MONTGOMERY COUNTY HISTORIC PRESERVATION COMMISSION
STAFF REPORT

Address:	3713 Underwood St., Chevy Chase	Meeting Date:	5/27/2020
Resource:	Clark House Individually Listed Master Plan Site	Report Date:	5/20/2020
Applicant:	Hannah Graae & Duke Schaeffer	Public Notice:	5/13/2020
Review:	HAWP	Tax Credit:	n/a
Case Number:	35/75-20A	Staff:	Dan Bruechert
Proposal:	Hardscape alterations, fence installation, Stair replacements

Porch Stairs and Pavers

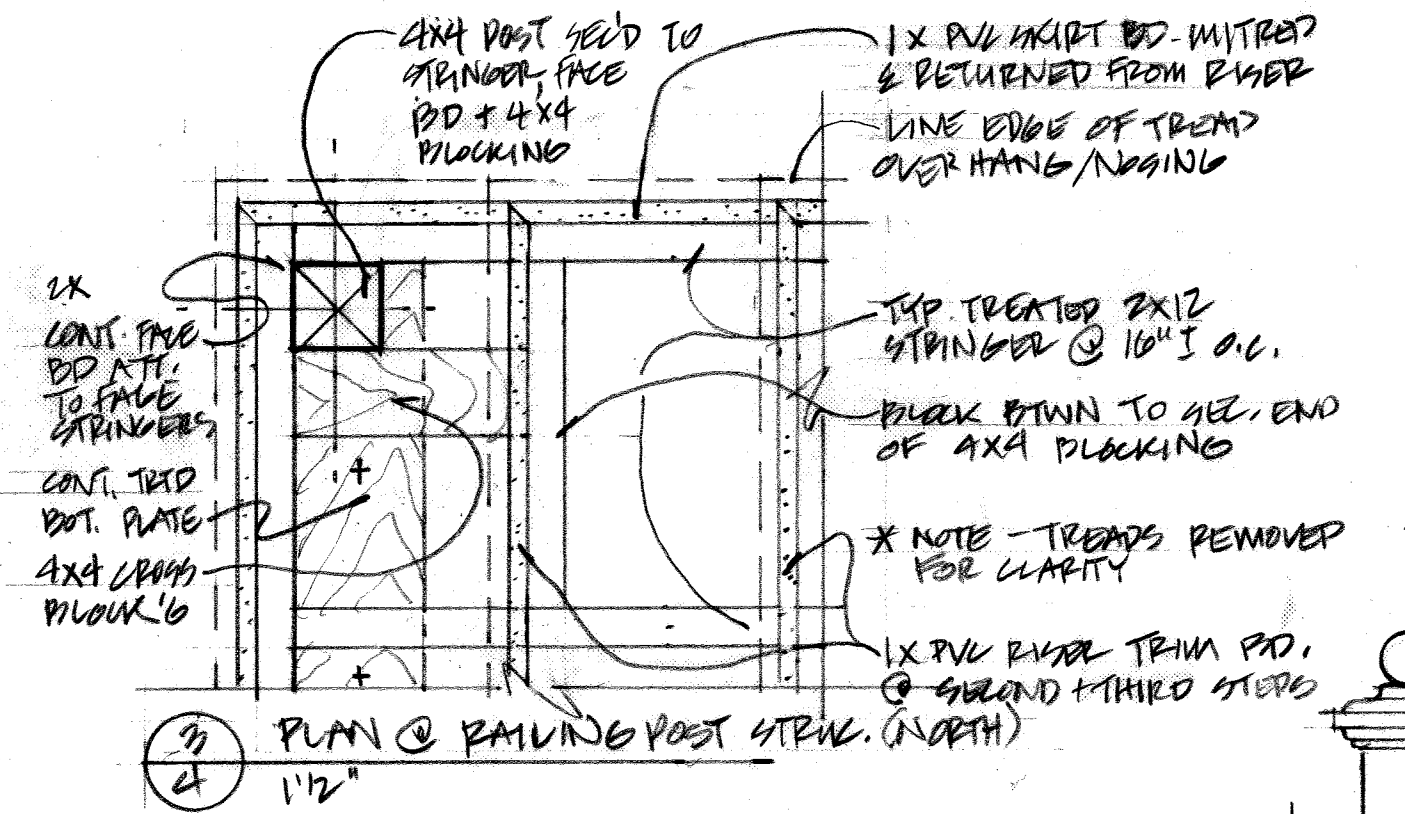
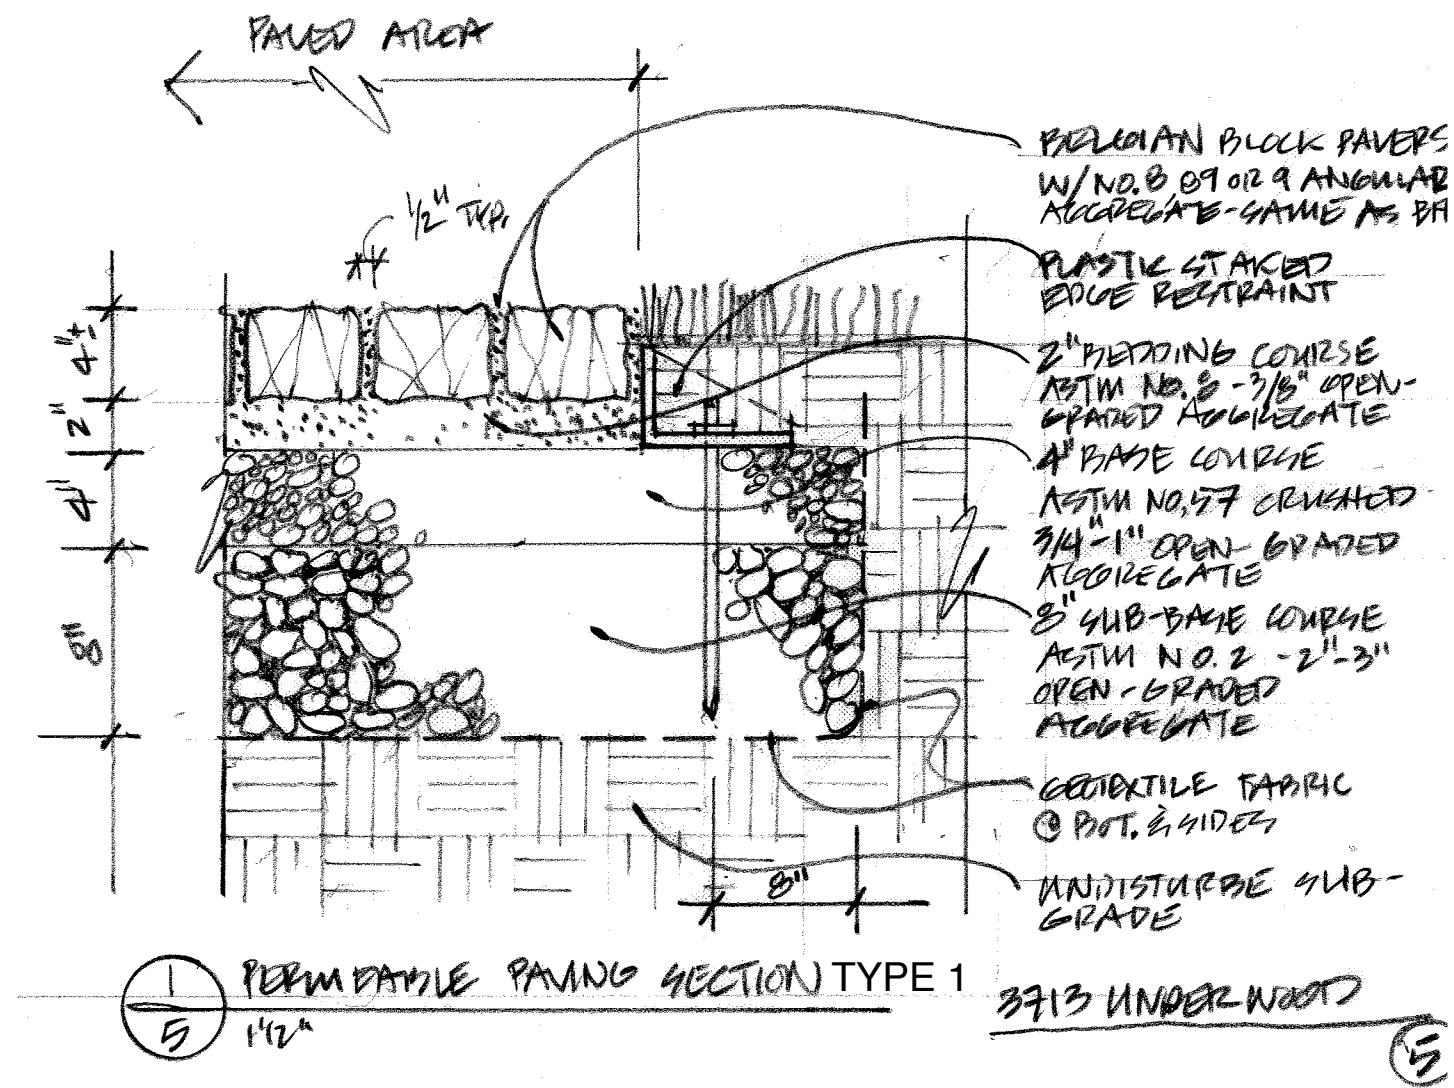
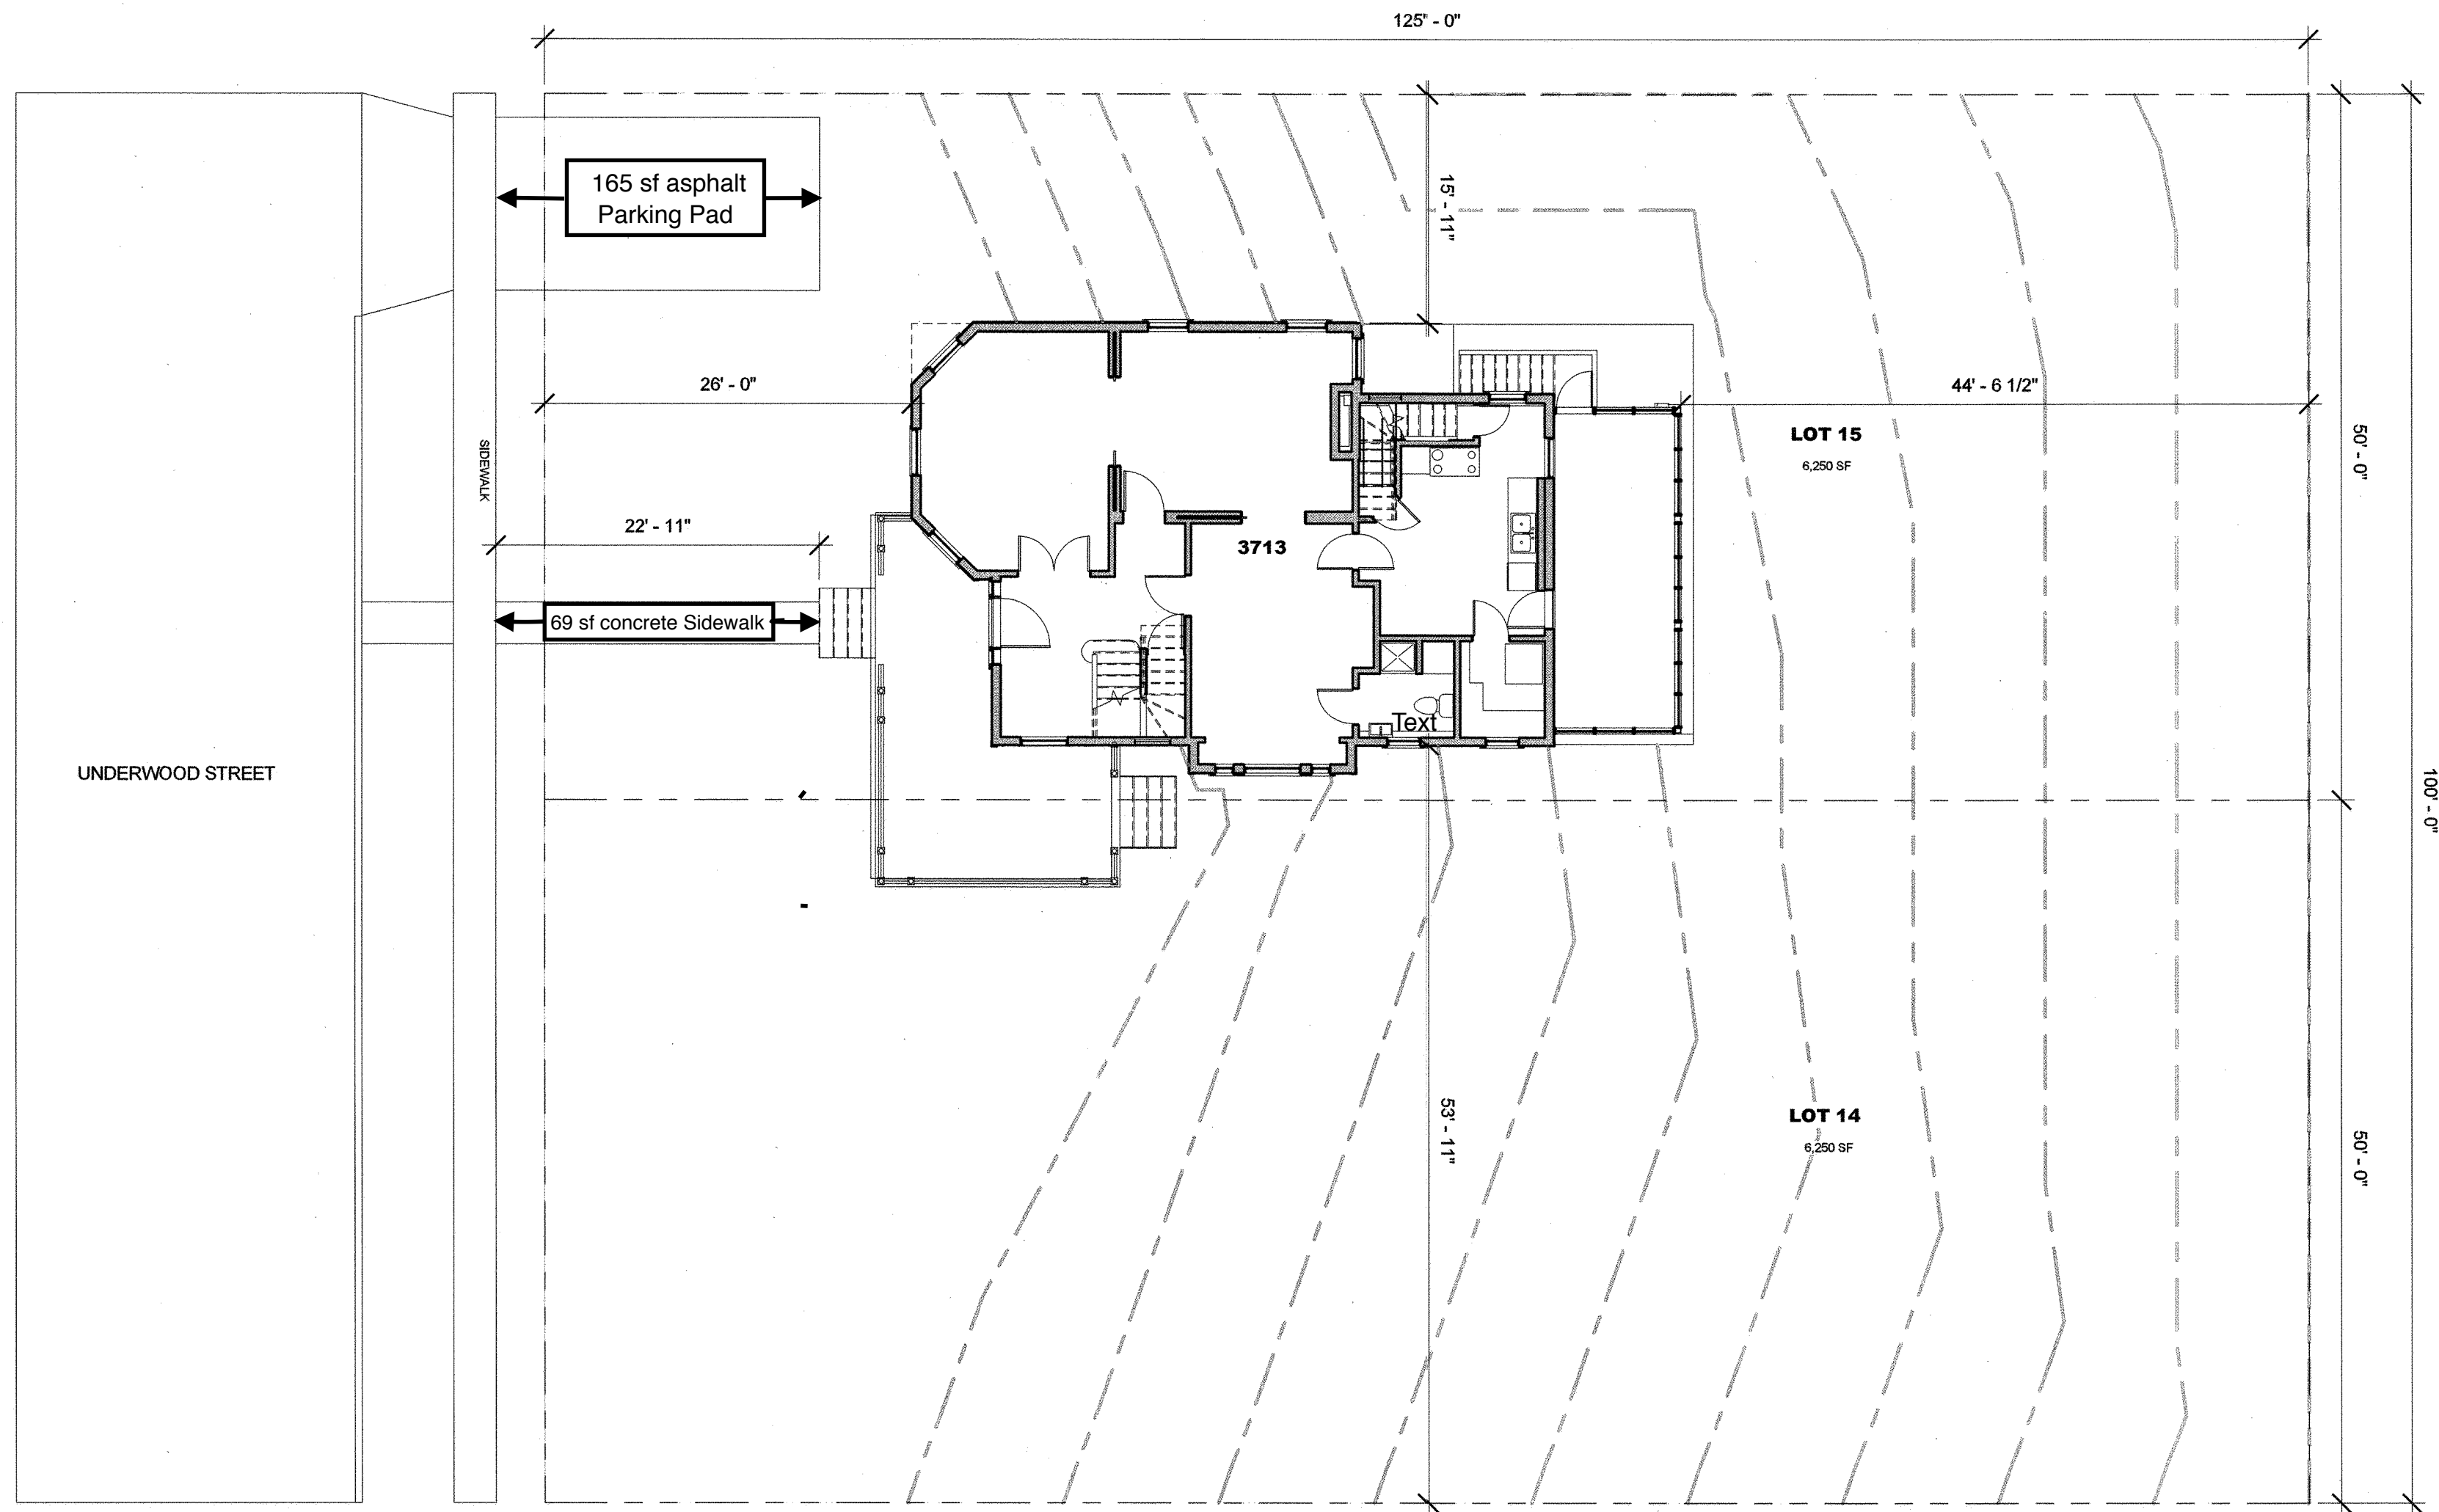
The applicant proposes several small alterations to the existing property hardscape: Enlarging the existing parking pad, a new paver walk from the sidewalk to the front stairs, a new walk from the parking pad to the front stairs, a small trash pad, and a new stepping stone path at the front through the proposed pergola.

The existing carport parking pad will be removed and a new Belgian block parking pad, expanded by 51 ft² (fifty-one square feet), will be installed in its place. Staff finds the expansion to be acceptable and that the proposed material is more compatible with the house than the existing asphalt.

The applicant proposes to remove the existing front concrete walk and install a wider flagstone walkway. Additionally, the applicant proposes to install a walkway from the parking pad to the front stairs. While this work will reduce the amount of grass in front of the house, Staff does not find that the proposal is out of character with the site (per Standards 2 and 24A-8(b)(2)) and does not find the landscaping is historically significant.

The third proposed alteration to the hardscape is the installation of a new pad for trash collection on the west elevation. The proposed pad will be 28 ft² (twenty-eight square feet) and covered in flagstone to match the proposed walkways. Additionally, the trash area will be obscured from the right-of-way by a wooden screen. Staff finds the materials proposed to be appropriate and the size of the new pad is so small as to have only a minor impact on the visual character of the site. Staff supports the approval of the trash pad under Standard 2 and 24A-8(b)(2).

Finally, the applicant proposes to introduce a step-stone walkway from the front porch to the fence gate (discussed below). This walkway will be created by placing flagstones on the ground with a section of grass between the stones. Staff finds that the proposed walkway, with grass

The side yard of the double lot is not fenced in. The applicant proposes installing a new 4' 6" (four foot, six-inch) wood picket fence to enclose the side yard. The fence is aligned with the rear of the front porch. At the center of the fence, the applicant proposes to install a wooden gate and a pergola.

Staff finds that the material and design are compatible with the historic resource. Typically, fences in front of the rear wall plane can be no more than 48" (forty-eight inches) tall. This height limitation is to preserve the open character of an environment and is applied most rigorously to historic districts, where the preservation of the streetscape is of primary importance. Staff finds that the placement of the proposed fence, set back from the front of the yard, will maintain views of the house from the surrounding area. Staff supports approval of the proposed fencing under 24A-8(b)(2) and Standard 2.

At the front porch, the applicant proposes to install new wooden stairs. The proposed stairs at the front will be slightly wider than the existing stairs but will maintain the rise and run. New wood handrails will also be installed with the new stair sets. Staff finds that the proposed stairs on the front porch are architecturally compatible with the historic character of the house. Staff finds that the original stairs were likely wood, which makes the proposal compatible with Standard 5.

On the west (left) side of the house, there is a wooden staircase that provides exterior access to the rear screened-in porch. The applicant proposes to removing this set of stairs and to install a new side loading staircase on the east side of the porch. The proposed stairs will be wood with a wood handrail. Staff finds the existing stairs are not historically significant and their removal will not detract from the historic character or significance of the resource. Staff finds the proposed stairs are an appropriate material (wood) and are placed in a location that will not detract from the historic character of the house.
